MINISTRY ASSESSMENT REPORT – DOCP APPROVAL

File:	17006	DOCP Submission Date	January 20, 2020
Application Date:	N/A	OC Last Amended	August 31, 2012
Application type:	DOCP Approval

Applicant:	Columbia Shuswap Regional District (CSRD)		
Application Purpose:	Updated DOCP		
Facility Type:	Municipal Landfill		
Facility Location:	Golden, BC		
WDR Schedule:	WDR Schedule 1 (Municipal Solid Waste Management)		
CPIX Ranking:	L	Complexity Category:	Medium

This DOCP was submitted on January 20, 2020, entitled “Golden Landfill Design, Operations and Closure Plan Update, Golden, BC” authored by Golder Associates Ltd. to cover future landfilling, closure, and post-closure. This landfill has approximately 60 years of operation left under the new fill plan.

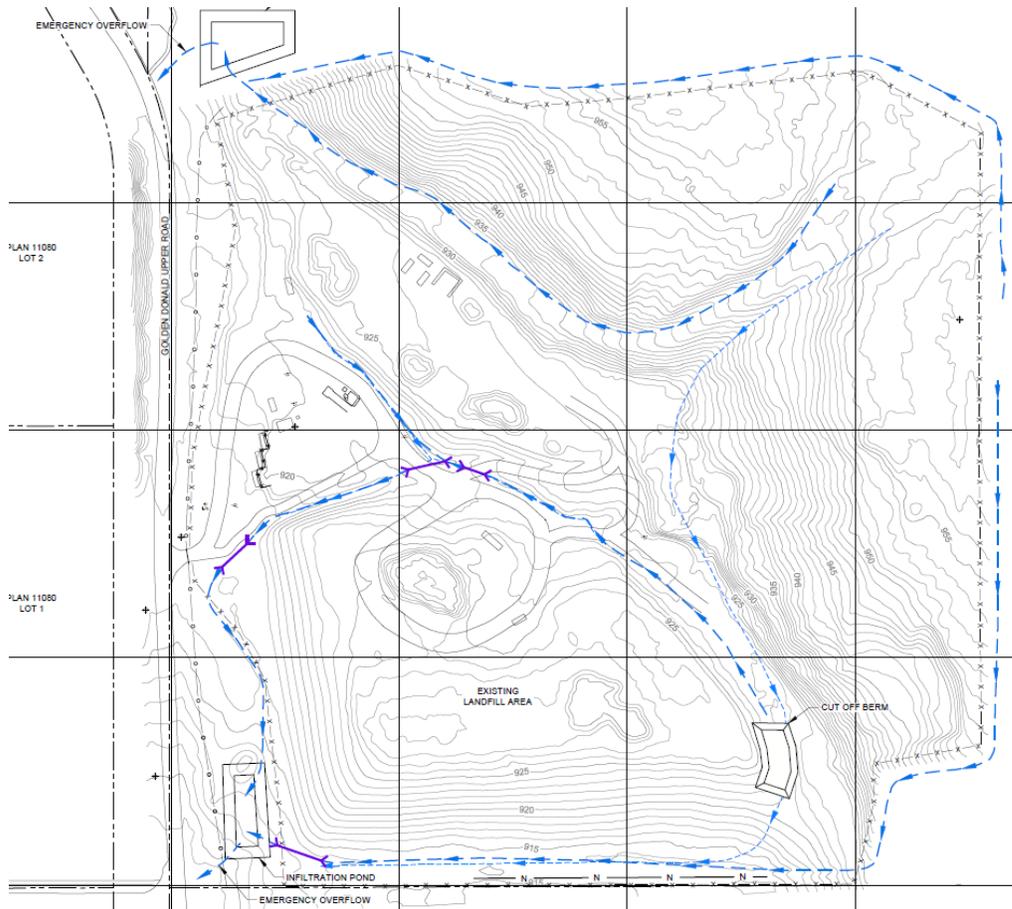
It should be noted that water quality guidelines and/or CSR standards are exceeded for arsenic, lithium, strontium, fluoride, iron, manganese and cobalt at the historically monitored wells, the new 2018 wells, and 8 domestic wells (see map below). Three of these wells are East of the landfill (side-gradient, or up-gradient, purple dots below), while 4 others surveyed in 2018 are far to the West, and up-gradient to the North, North-West or East (green dots below). These exceedances for these parameters were interpreted by WWAL to be “naturally occurring within the bedrock” as distribution was widespread and predominantly up-gradient.
